# AGENDA VILLAGE OF PLEASANT PRAIRIE PLEASANT PRAIRIE VILLAGE BOARD PLEASANT PRAIRIE WATER UTILITY PLEASANT PRAIRIE SEWER UTILITY Village Hall Auditorium 9915 - 39th Avenue Pleasant Prairie, WI December 5, 2016 6:00 p.m.

SUBJECT: Fire Department review of plans for Care Animal Hospital

These are updated comments for the plans dated 9/28/2016 received for Care Animal Hospital to be located at 9052 Prairie Ridge Blvd.

### PUMPER PAD FDC DETAIL

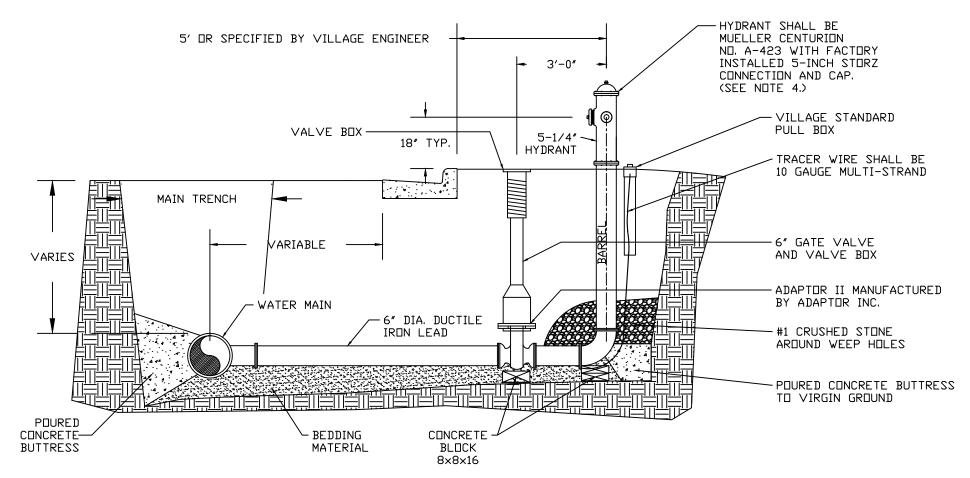
- All outside doors shall have a lock and handle for access from the outside of the structure.
- Need to install the approved fire department connections, Pumper Pads. Drawing depicts FDC & hydrant located at the far Eastern portion of the parking lot.

A1.0

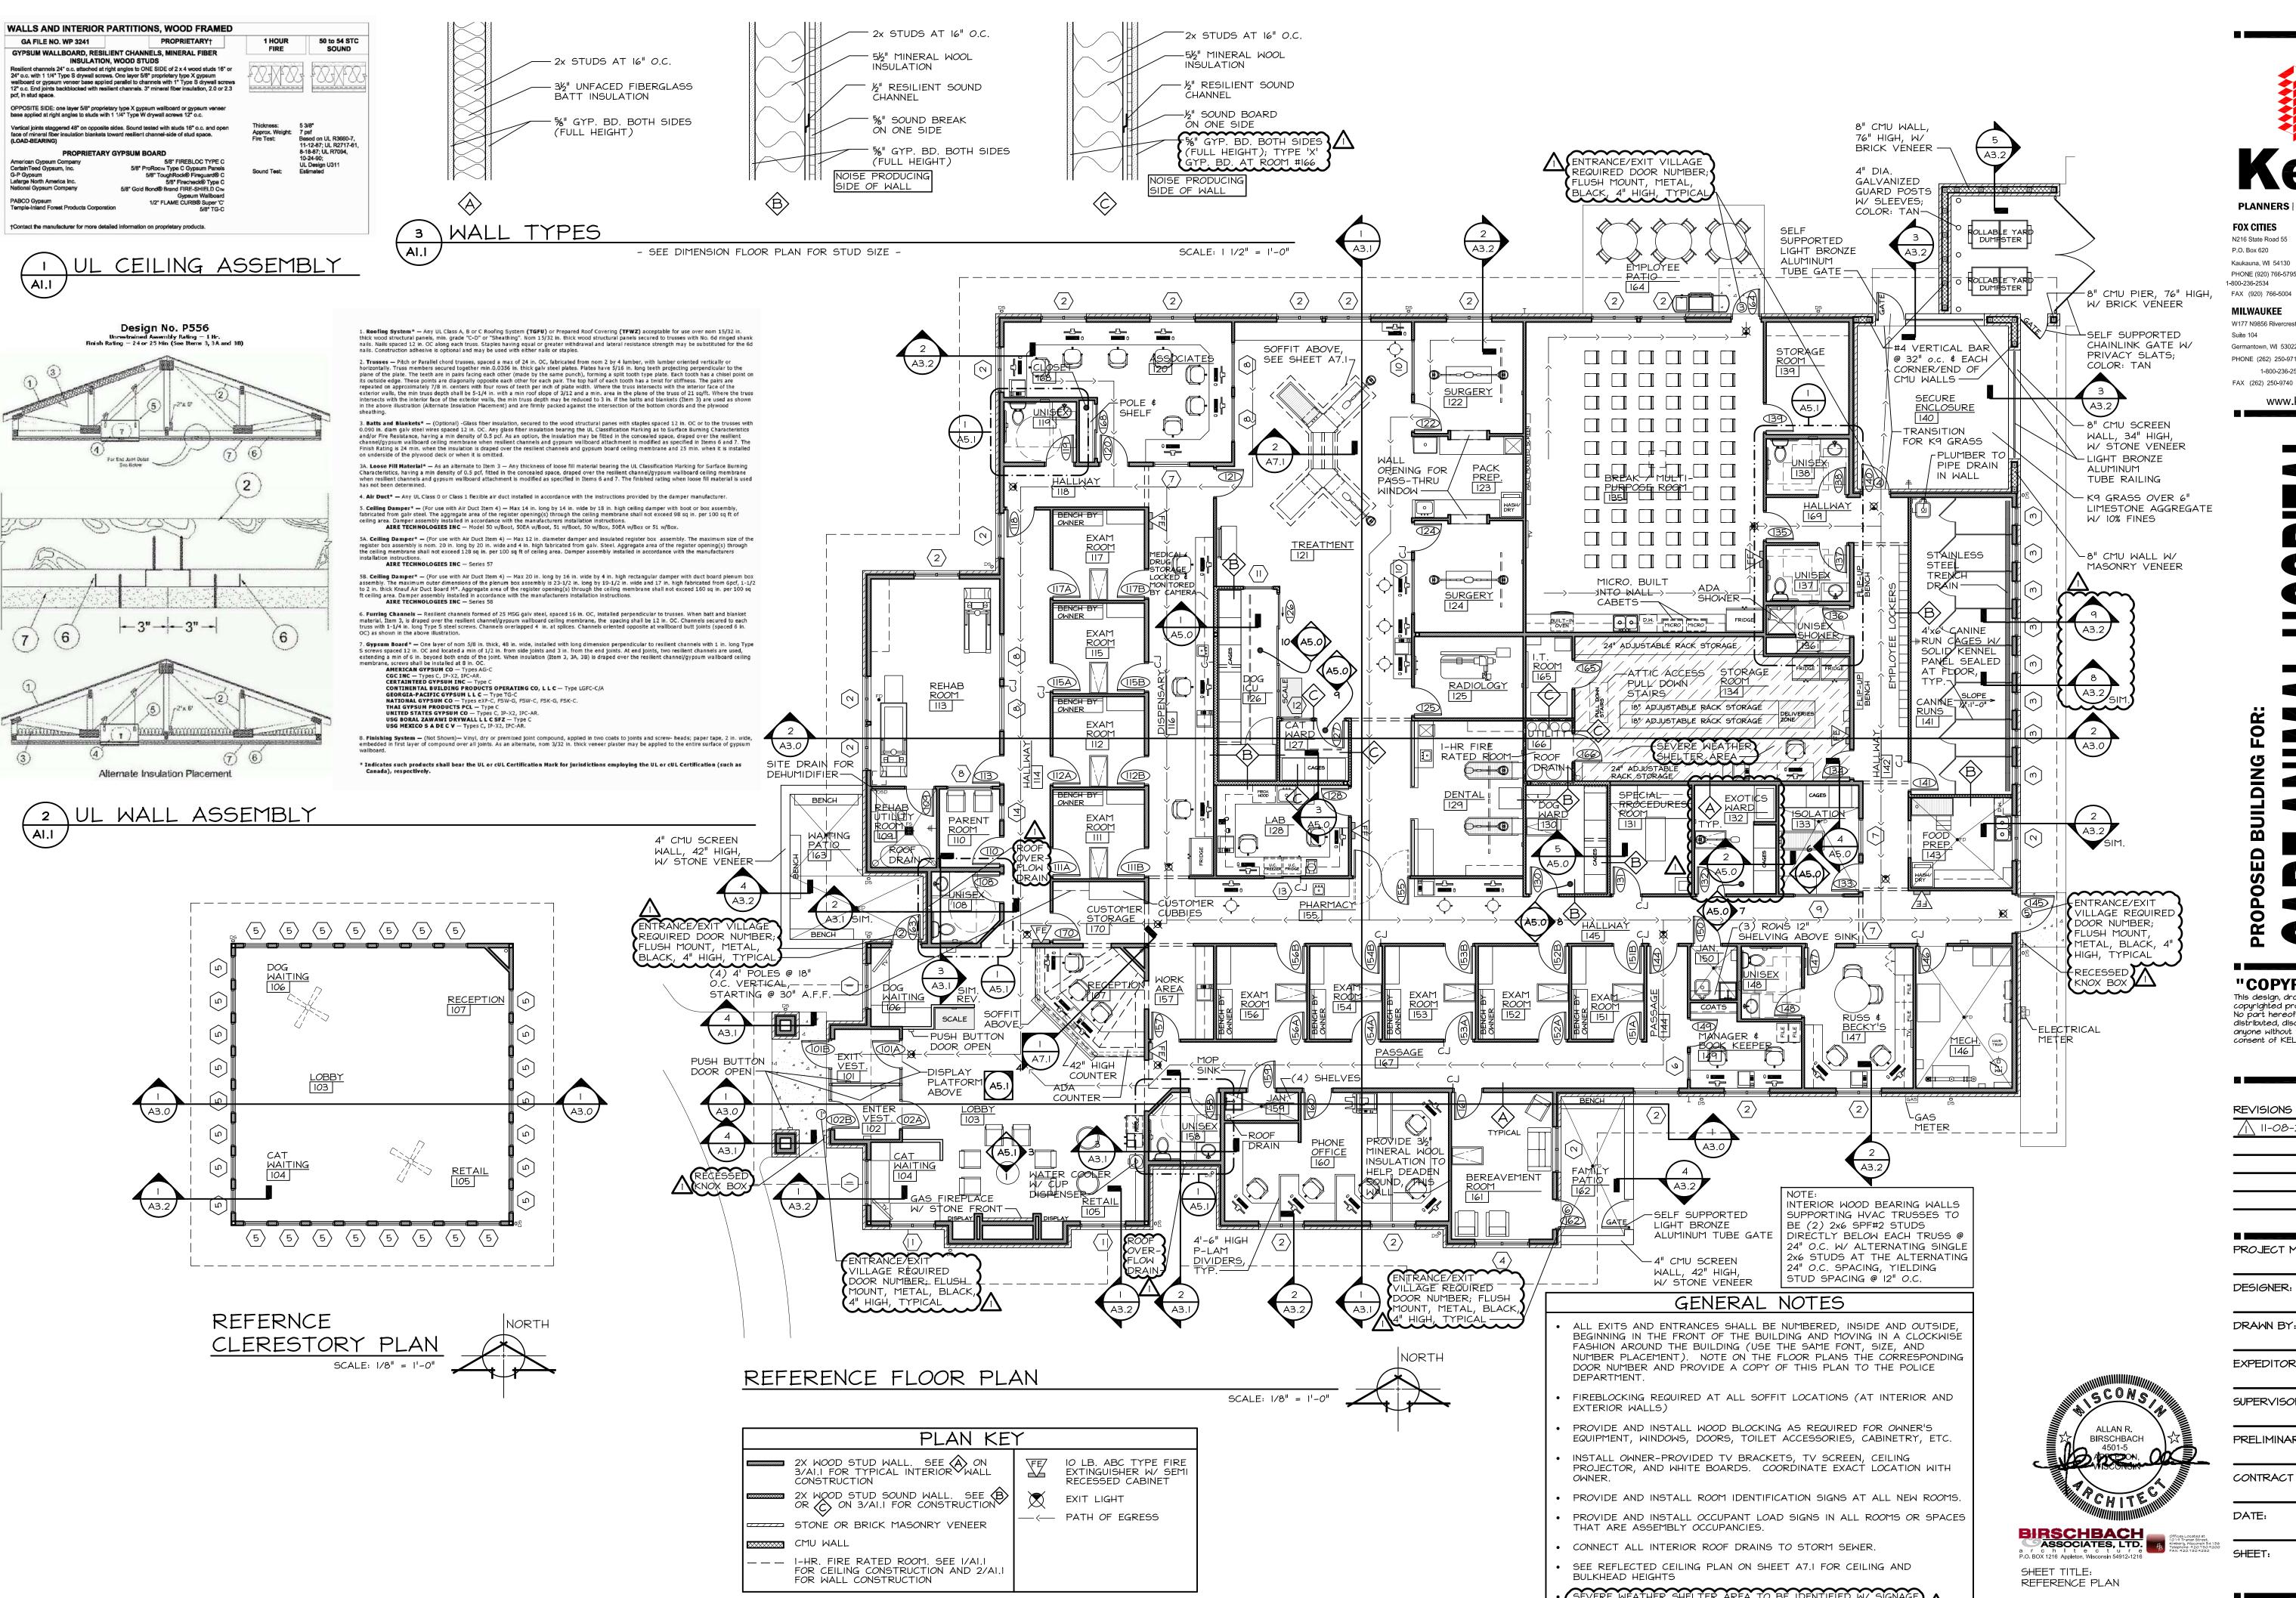
- Fire Alarm Control Panel: The main FACP must be placed in the fire sprinkler riser room (146). FACP location not depicted on drawing. Full function addressable remote annunciator panel to be located at the Enter Vestibule (102) location. Ensure open door swing does not occlude annunciator panel access.

- Knox Boxes shall be recessed in the building. Knox boxes shall be provided at the main entrance and at the sprinkler riser room. Locations as depicted on drawing are acceptable. Review Appendix A for specific Knox Box location installation.
